## **Executive Summary for Comments of Citizens for Pennsylvania's Future and The Group Against Smog and Pollution on the Proposed Attainment Demonstration for the Liberty-Clairton PM2.5 Nonattainment Area**

**COMMENTS OF CITIZENS FOR PENNSYLVANIA'S FUTURE AND THE  
GROUP AGAINST SMOG AND POLLUTION ON THE PROPOSED  
ATTAINMENT DEMONSTRATION FOR THE LIBERTY-CLAIRTON PM2.5  
NONATTAINMENT AREA**

**Figure 1: Occupied Homes in Areas Modeled to Exceed the 15  $\mu\text{g}/\text{m}^3$  Annual Standard**

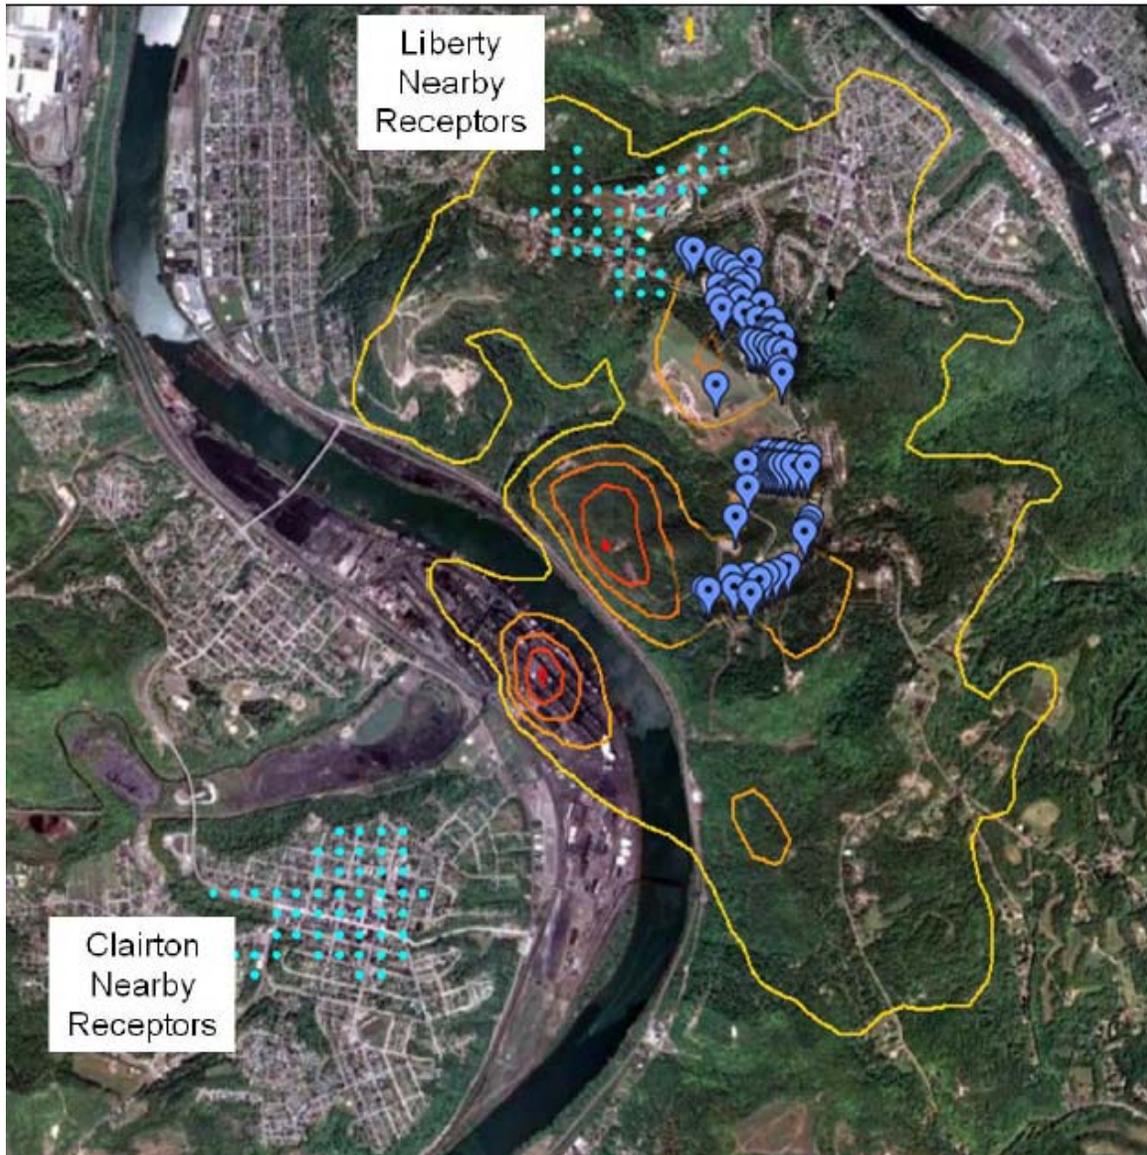
The SIP attempts to justify this omission by arguing that the health and welfare of the residents in this high pollution zone may be sacrificed because “the Lincoln hillside is not suitable as a neighborhood-scale location for analyzing PM<sub>2.5</sub> because it does not represent a populated area.”<sup>7</sup> To test this assertion, GASP surveyed the area expected to be affected (within red and orange lines marked on Figure 8-1), and found 80 occupied homes.<sup>8</sup> The residents of this neighborhood must not be consigned to lifelong exposure to pollutant levels that are known to be deadly.

The SIP also suggests that the regional scale modeling is not suited for comparing resulting concentrations directly with the NAAQS. The SIP explains that these models are used only to determine the relative change in emissions needed to estimate the amount of emission reduction needed to provide for attainment at monitored locations. The regional scale models used (CALPUFF and CMAQ) generate estimates of pollutant concentrations at 500-meter intervals within the area considered to be represented by the Liberty Borough monitor.

But it is precisely because the regional scale models are blunt instruments that are not suited to predicting concentrations on the neighborhood scale near the plant where

pollutant levels will be highest that EPA warned “that nonattainment areas with potential hotspot issues (relatively high concentrations and/or gradients of primary PM<sub>2.5</sub>) should not rely exclusively on regional modeling.”<sup>9</sup> Instead, EPA “describe[d] an ‘unmonitored area analysis’ which uses interpolated ambient data combined with gridded model outputs to examine whether potential violations of the NAAQS may occur in unmonitored areas. If potential violations are indicated, we recommend further analysis of the problem through additional local modeling. Options for State action to address such a situation could include imposition of reasonably available control technology to reduce emissions, or the deployment of an air quality monitor to further characterize the problem.”<sup>10</sup> ACHD has not chosen either option recommended by EPA. Instead, the draft SIP would sacrifice human health to avoid imposing additional control measures on the Clairton Works. Not requiring the emission reductions needed for attainment wherever the public has access violates the Clean Air Act.

- Direct the staff at ACHD to perform additional air quality modeling using dispersion models to determine the additional reductions of direct particles emitted from sources within the nonattainment area that must be obtained to provide for attainment of both the annual and revised 24-hour Standard at all residences in the County where exposure to fine particle pollution is expected to be higher than at the monitor in Liberty Borough.
